CITY OF KNOXVILLE CLOSURE OF PUBLIC RIGHT-OF-WAY

► **FILE #:** 3-B-22-SC

► **RIGHT-OF-WAY TO BE
CLOSED:** Patton St.

► **LOCATION:** Between the southern line of Willow Street and a point 98.44 ft to the south

File No. 3-B-22-VA (Sewer)

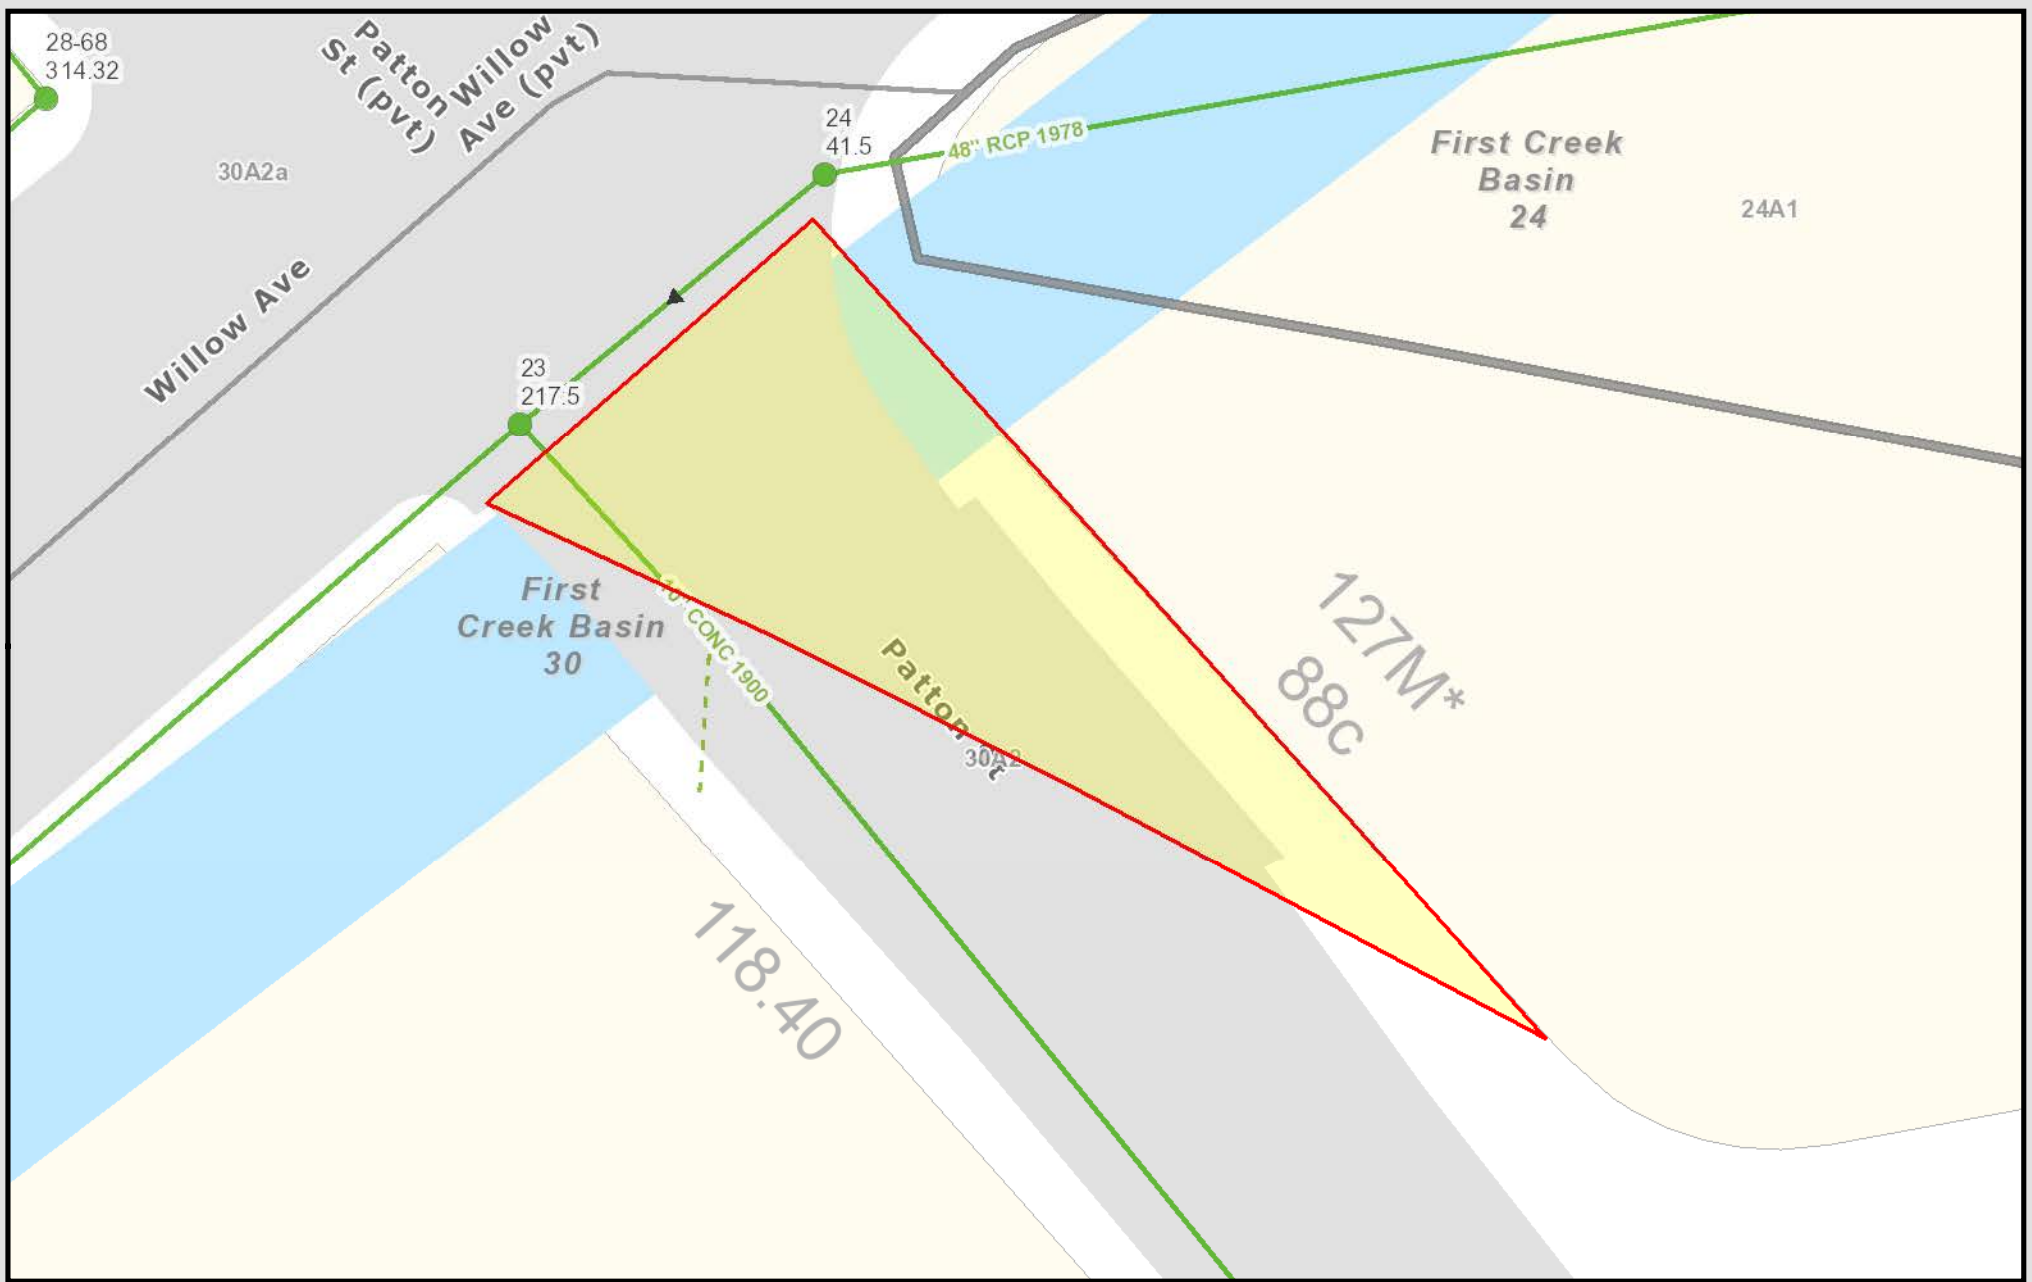
We have reviewed our records and find that we have existing utility facilities located within the subject right-of-way. The approximate locations of these facilities are indicated on the enclosed prints. However, KUB does not release and hereby retains all easements and rights for existing utility facilities, whether or not shown on these prints.

Should this right-of-way be closed, KUB will require the following permanent easements for its utility facilities.

Sewer (10") – 7.5 feet on each side of the centerline of the sewer line, 15 feet total width

Sewer (48") – 12.5 feet on each side of the centerline of the sewer line, 25 feet total width

File No. 3-B-22-VA (Water)

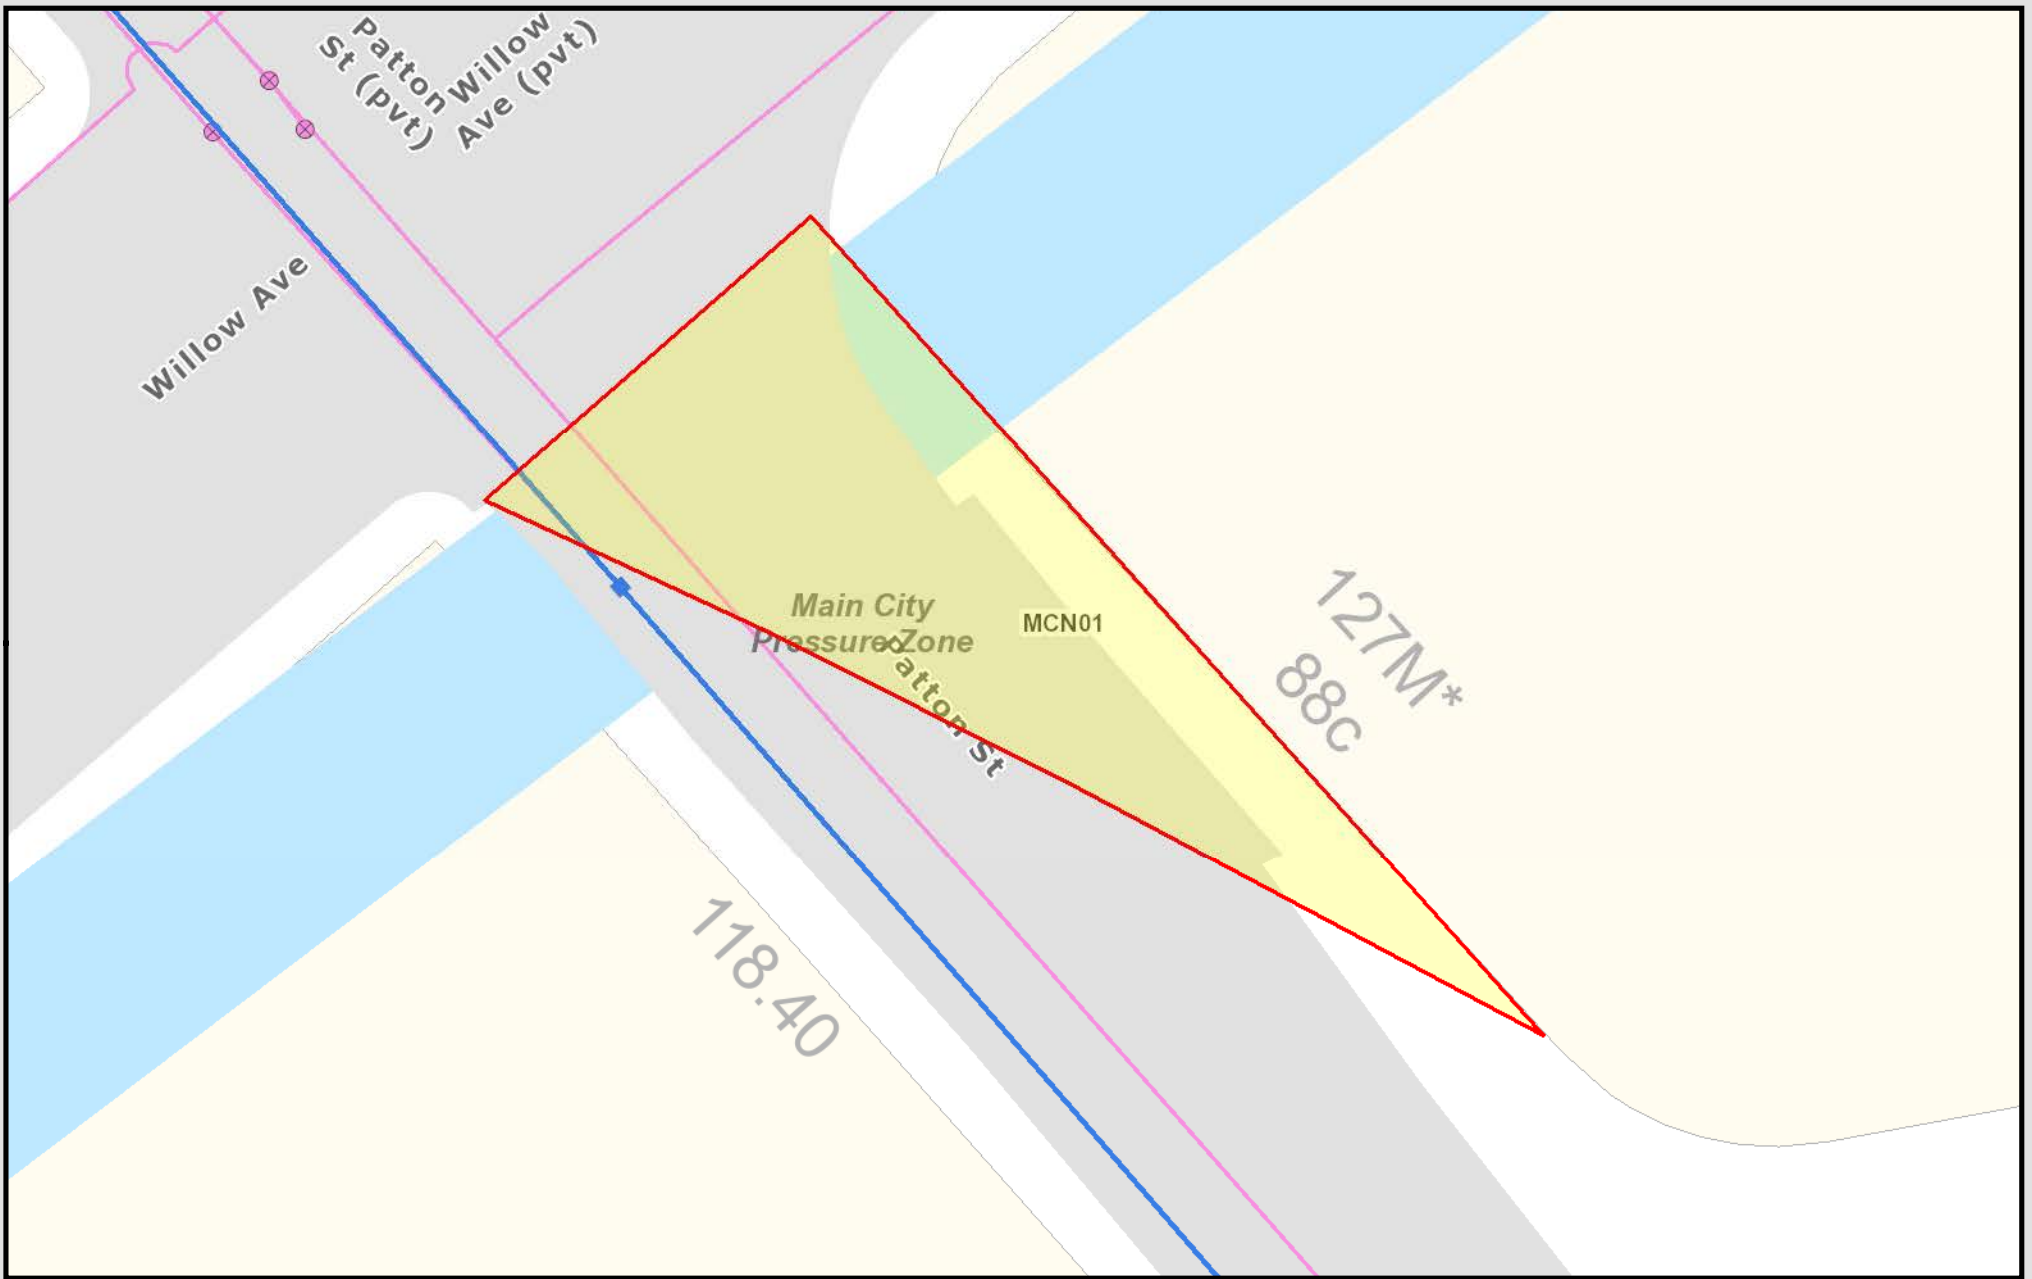
Water – 12.5 feet on each side of the centerline of the water line, 25 feet total width

File No. 3-B-22-VA (Gas)

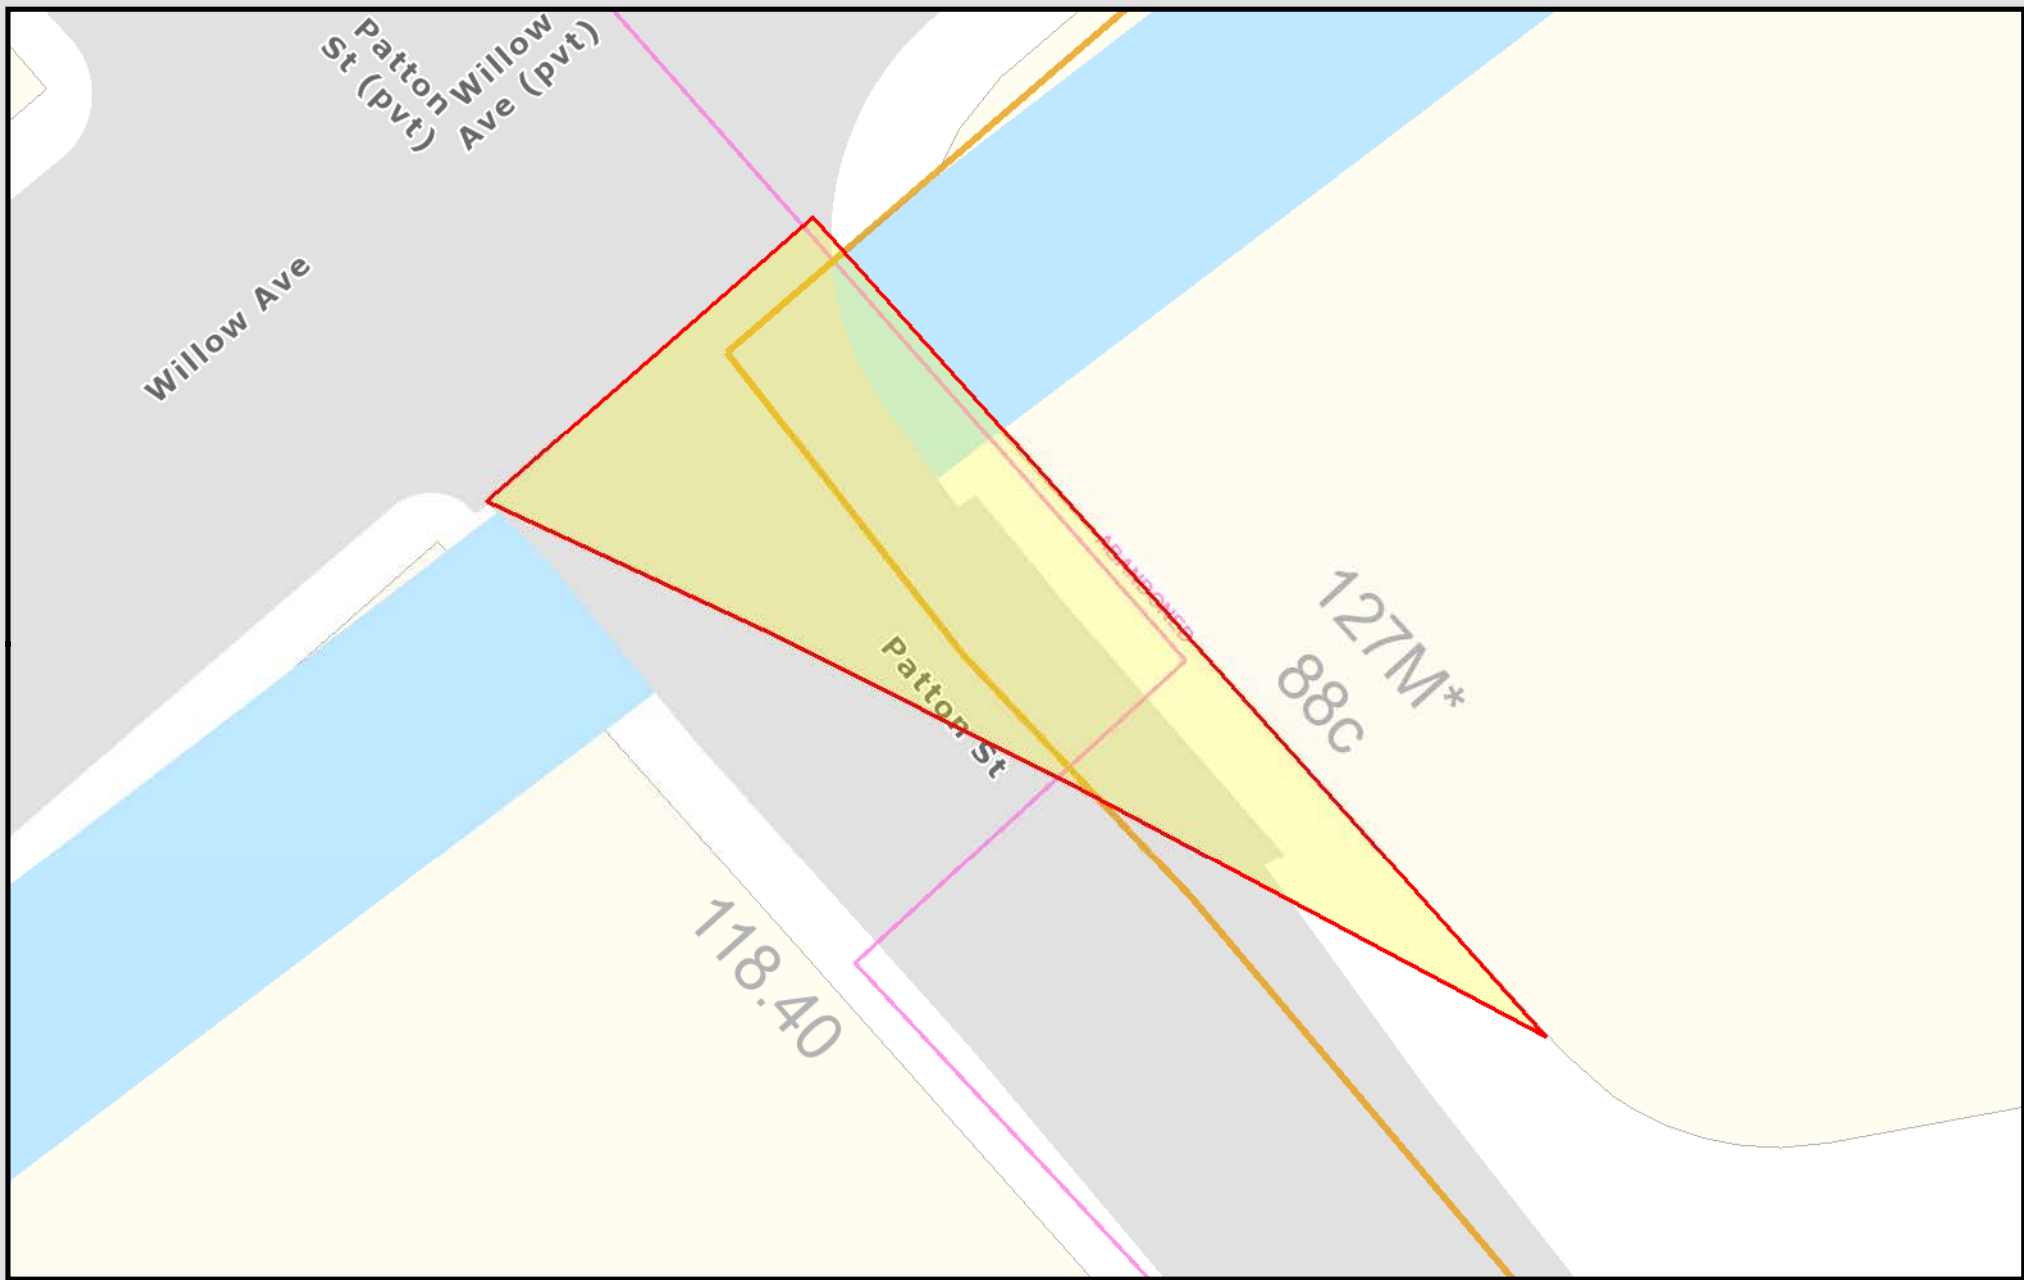
Gas – 12.5 feet on each side of the centerline of the gas line, 25 feet total width
